Project: **Wheaton Headquarters Auditorium Audio/Visual Technology**

RFP No.: P 40-105

SUBJECT: Addendum Number Three

### Network Diagram

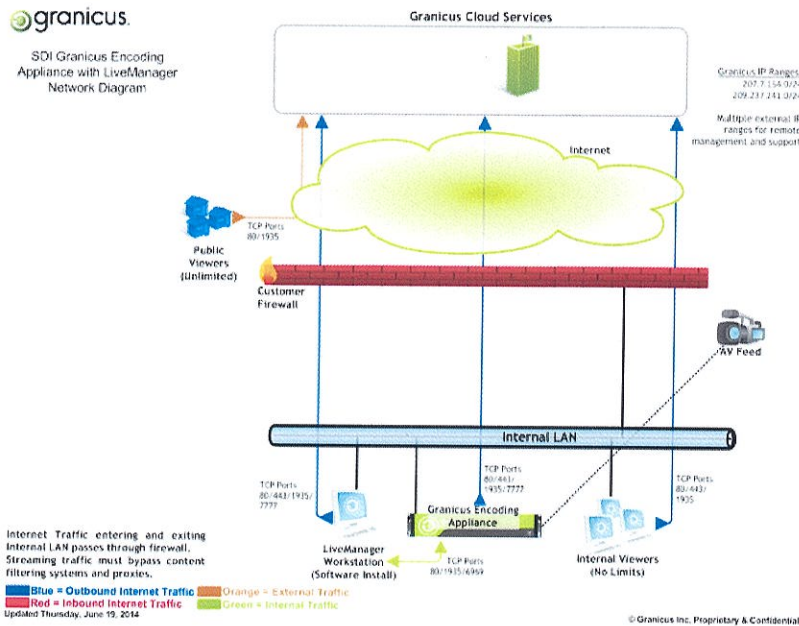
20. Does Planning still use the Tricaster? **No.**
21. Explain the connection to Granicus – is it over a network or hard-plugged in? **AV Feed is hardwired to encoder. See diagram below.**
